[Docket No. FAA-2012-1297; Directorate Identifier 2012-SW-100-AD; Amendment 39-17285; AD 2012-25-04]

Airworthiness Directives; Eurocopter France Helicopters

ACTION: Final rule; request for comments.

2012–25–04 Eurocopter France:

3.3.3 IN-FLIGHT VIBRATIONS FELT IN THE PEDALS

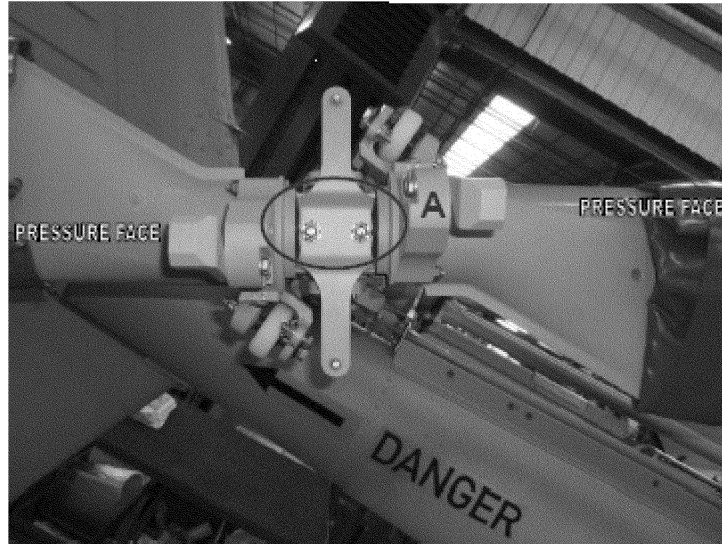
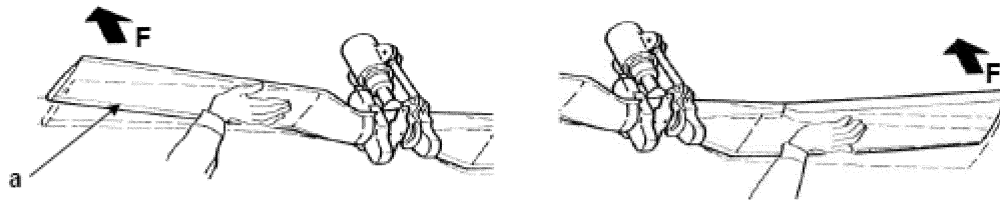
(iii) Add the following as paragraph 3.3.3 to the RFM:

1. CHECK PEDAL EFFECTIVENESS
2. SMOOTHLY REDUCE THE SPEED TO VY
3. AVOID SIDESLIP AS MUCH AS POSSIBLE

LAND AS SOON AS POSSIBLE

Figure 1 to paragraph (f)

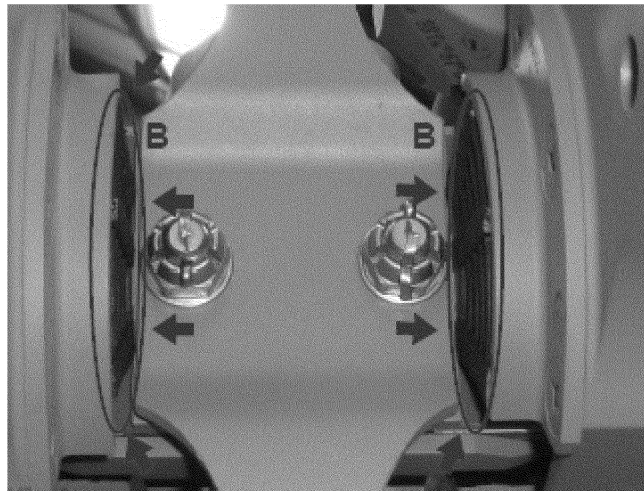
- (i) Position both tail rotor blades horizontally.
- (ii) Apply load (F) by hand, perpendicular to the pressure face of one tail rotor blade (a), as shown in Figure 1 to paragraph (f) of this AD, taking care not to reach the extreme position against the tail rotor hub. The load will deflect the tail rotor blade towards the tail boom.
- (iii) While maintaining the load, check all the visible faces of the bearings (front and side faces) in area B of DETAIL A of Figure 1 to paragraph (f) of this AD for separation between the elastomer and metal parts, a crack in the elastomer, or an extrusion (see example in Figure 2 to paragraph (f) of this AD). A flashlight may be used to enhance the check.

Figure 3 to paragraph (f)

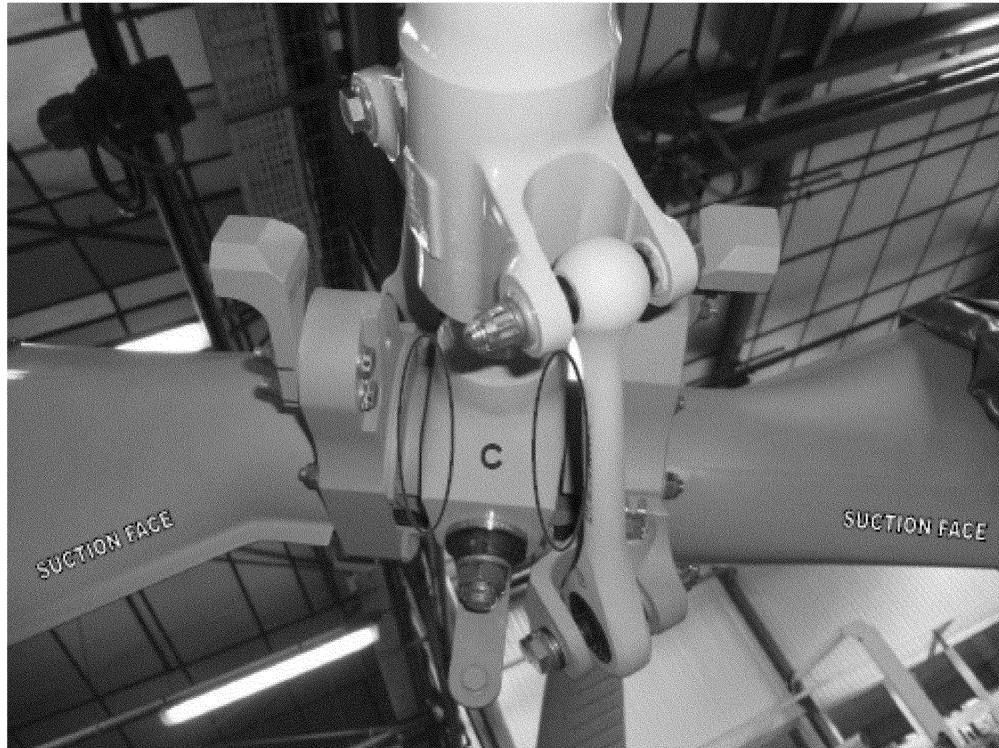
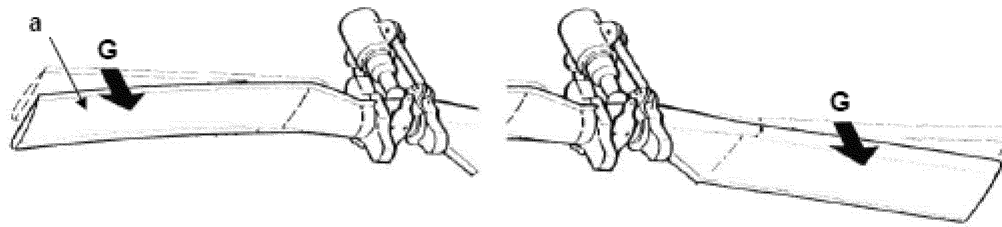
(v) Apply load (G) by hand perpendicular to the suction face of one tail rotor blade as shown in Figure 3 to paragraph (f) of this AD.

(vi) While maintaining the load, check visible faces of Area C as shown in Figure 3 to paragraph (f) of this AD for any extrusion. A flashlight may be used to enhance the check.

Figure 4 to paragraph (f)

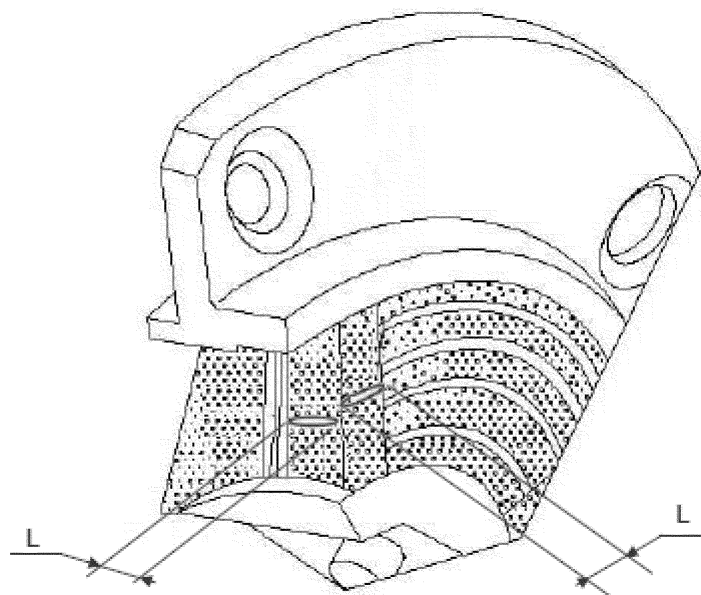
(6) If there is a separation or a crack on the pressure side bearing, measure the separation or the crack. If the separation or crack is greater than 5 millimeters (.196 inches) as indicated by dimension “L” in Figure 4 to paragraph (f), before further flight, replace the four bearings with airworthy bearings.
